**February 20, 2019**  
**BOARD OF COUNTY COMMISSIONERS**  
**ORANGE COUNTY, FLORIDA**  
**Addendum No. 2, IFB Y19-724-RC**  
**MOSS PARK RESTROOM**

**Bid Opening Date: March 5, 2019**

**DEMOLITION AND EROSION CONTROL PLAN**

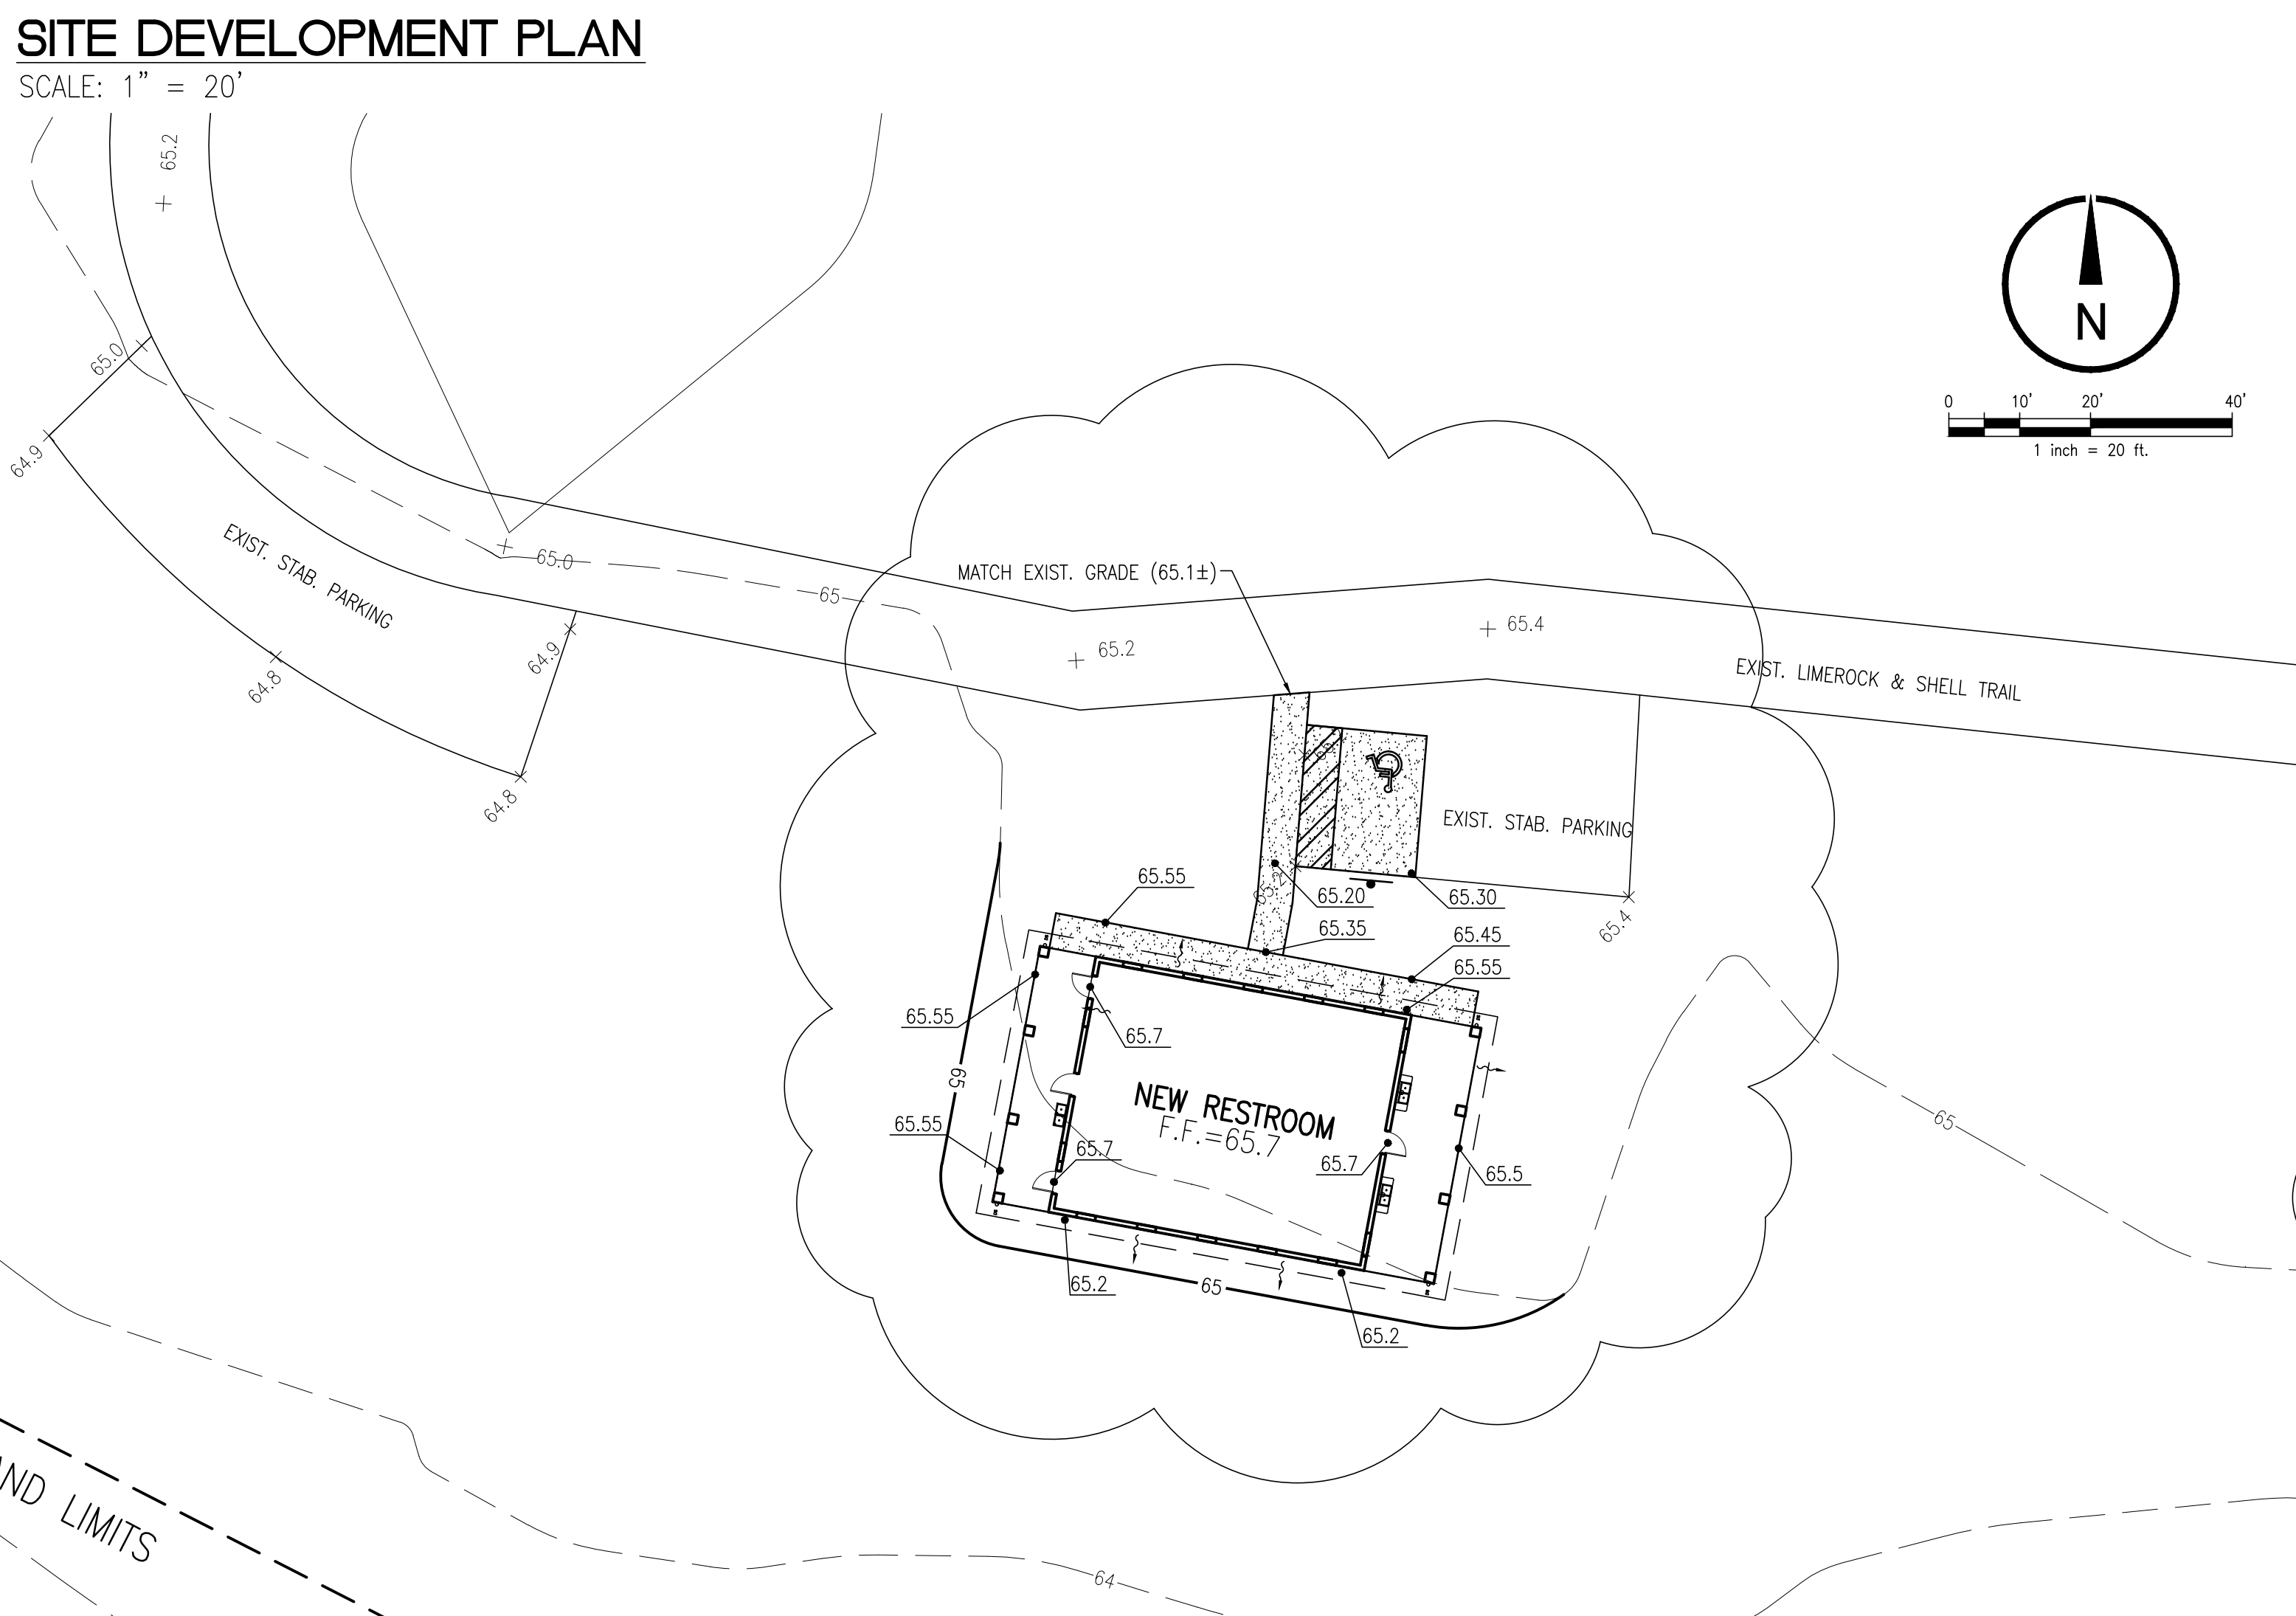
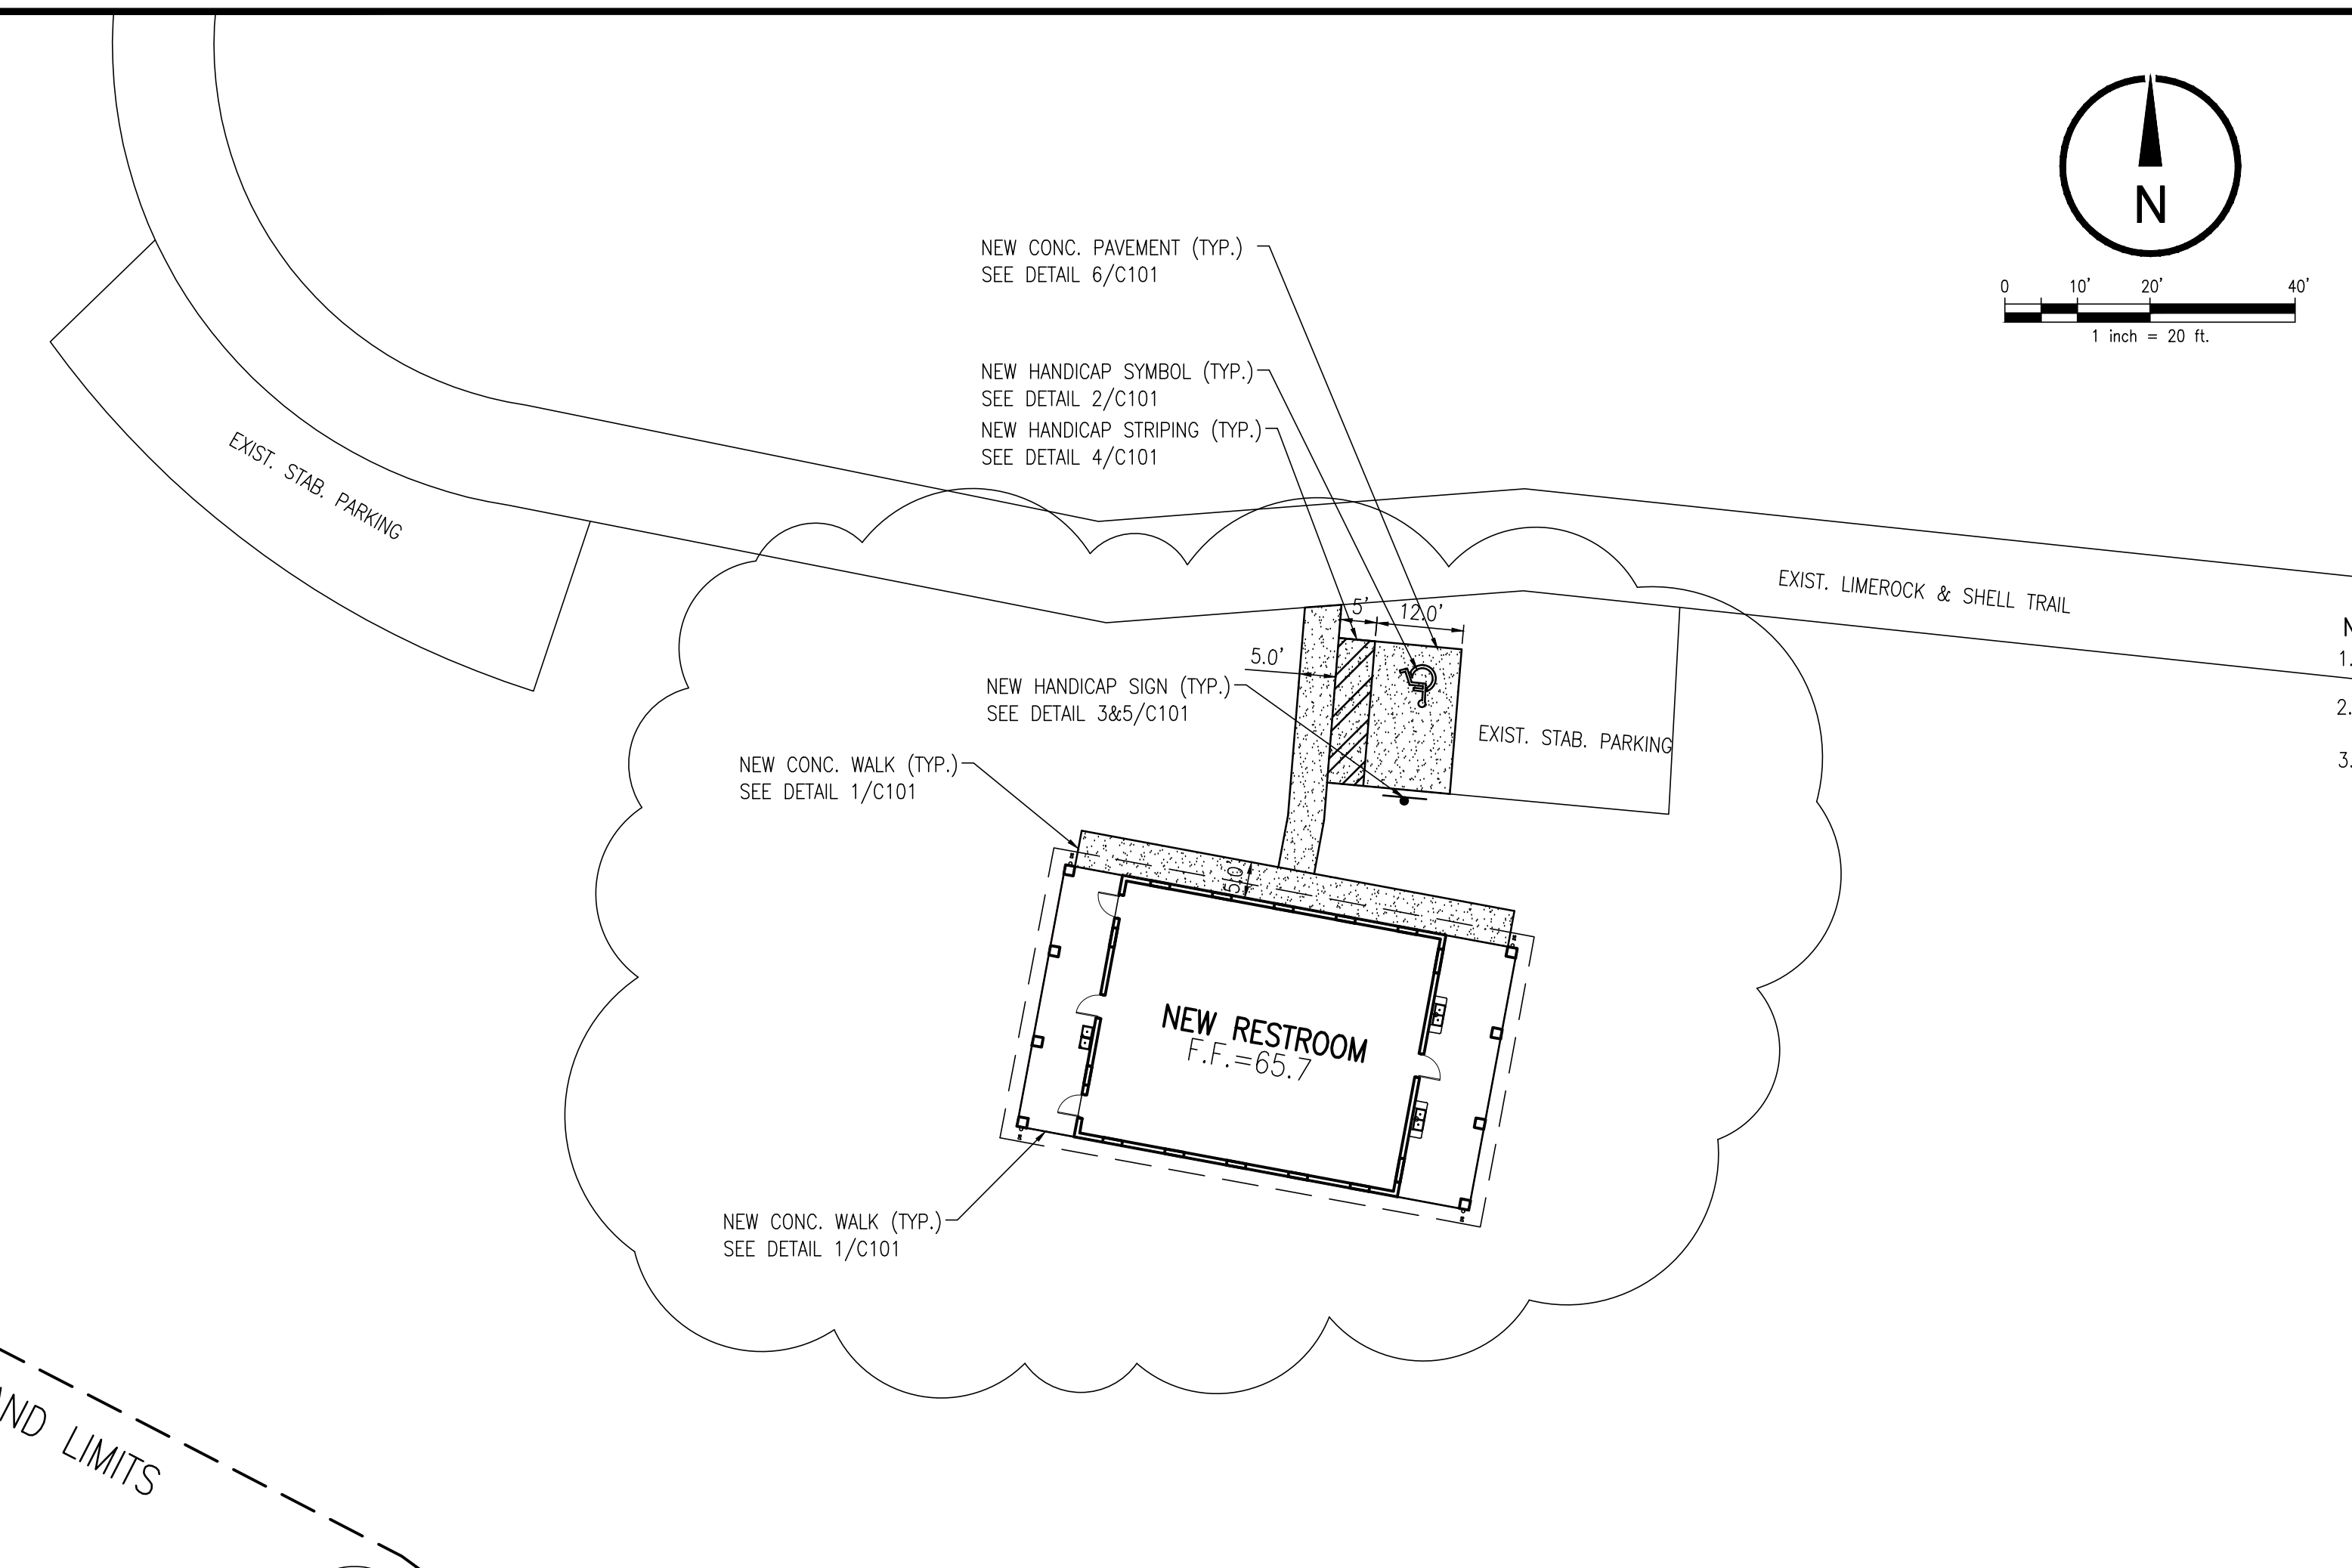
**2. Revision:** The following drawings have been revised to account for the changed Building location:

- C001: Demolition and Erosion Control Plan dated 2-18-19
- C101: Site Development and Grading Plan dated 2-18-19
- C301: Utility Plan dated 2-18-19
